| Project                      | <b>IEEE 802.16 Broadband Wireless Access Working Group</b> < <a href="http://ieee802.org/16">http://ieee802.org/16</a> >   |  |
| Title                        | <b>Sleep Mode Generic Mechanism</b>  |  |
| Re:                          | The document supports a comment at Sponsor Ballot on 802.16e/D5 document   |  |
| Abstract                     | The documents suggests text changes to incorporate different cases of Sleep Mode operations into a single scheme   |  |

Power Saving Class for multicast connection

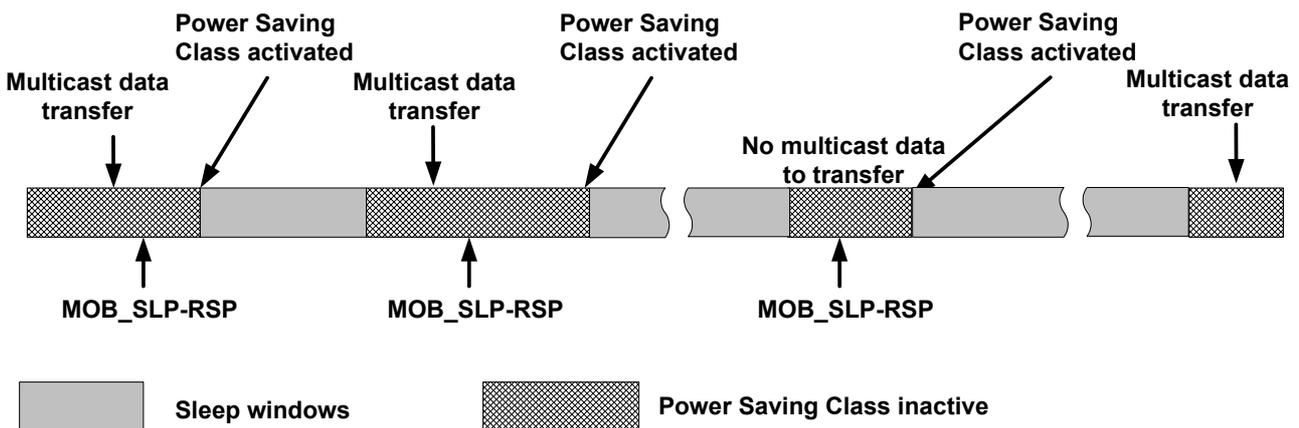
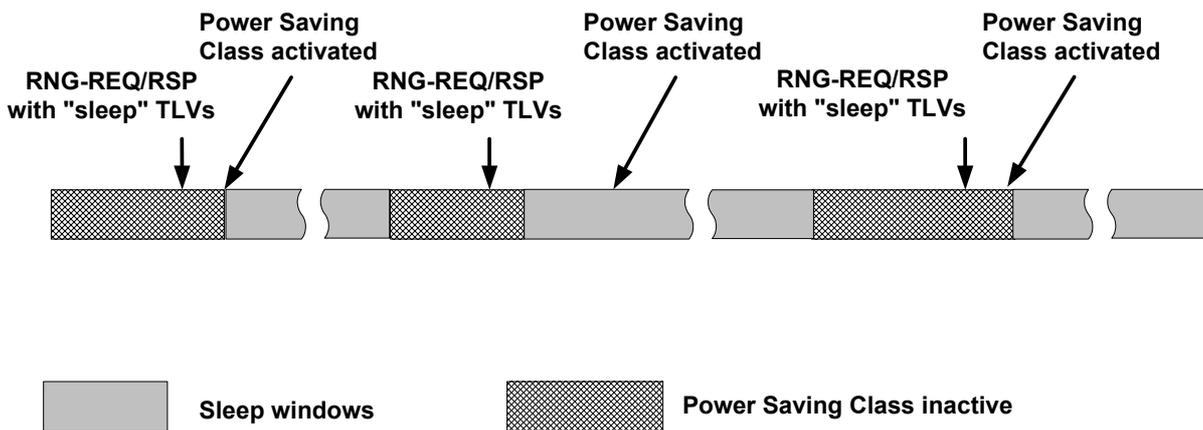
The following picture illustrates suggested Sleep implementation for multicast connection. The corresponding Power Saving Class is associated with the corresponding multicast connection. When activated (by MOB\_SLP-RSP from BS), the class of this type provides a single sleep window. After expiration of sleep window, the MSS is awake and if multicast data is already available, it may be transferred, otherwise Power Saving Class is re-activated and the MSS enters sleep window.

Figure NNN. Example of Sleep Mode Operations with two Power Saving Classes

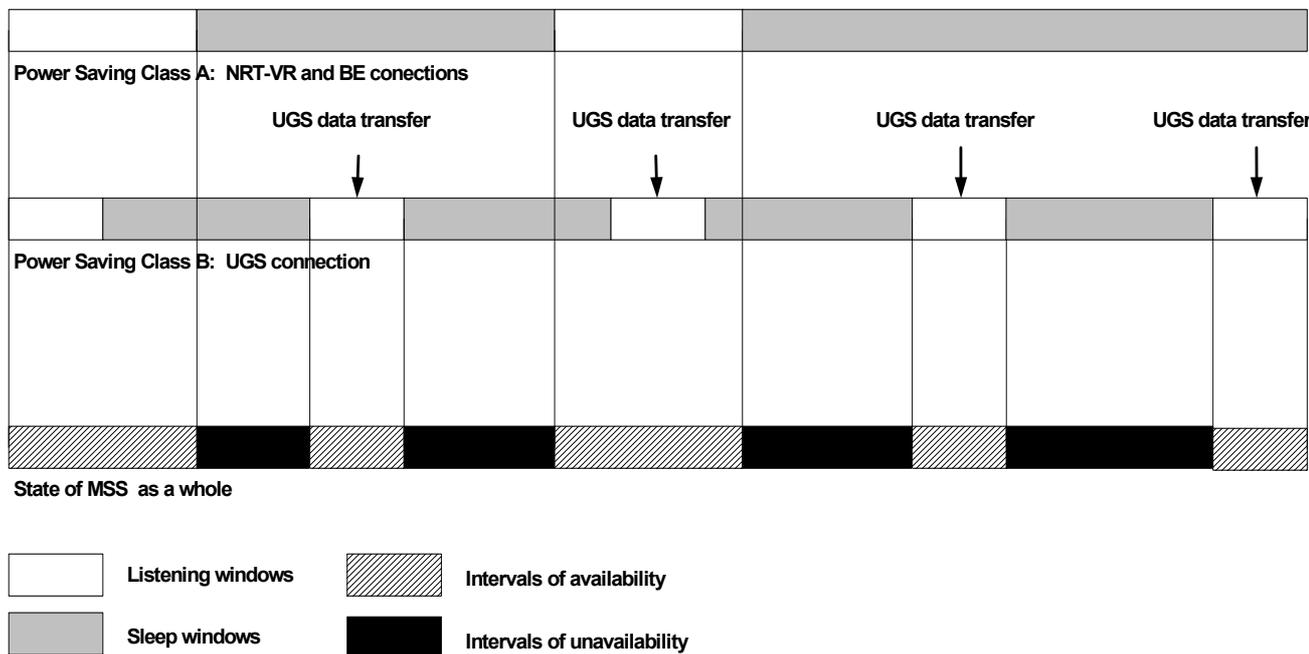
Figure NNN describes example of behavior of MSS with two Power Saving Classes: Class A contains several connections of BE and NRT-VR type, Class B contains a single connection of UGS type. Then for Class A the BS allocates sequence of listening window of constant size and doubling sleep window. For Class B the BS allocates sequence of listening window of constant size and sleep window of constant size. The MSS is considered unavailable (and may power down) within windows of unavailability, which are intersections of sleep windows of A and B.
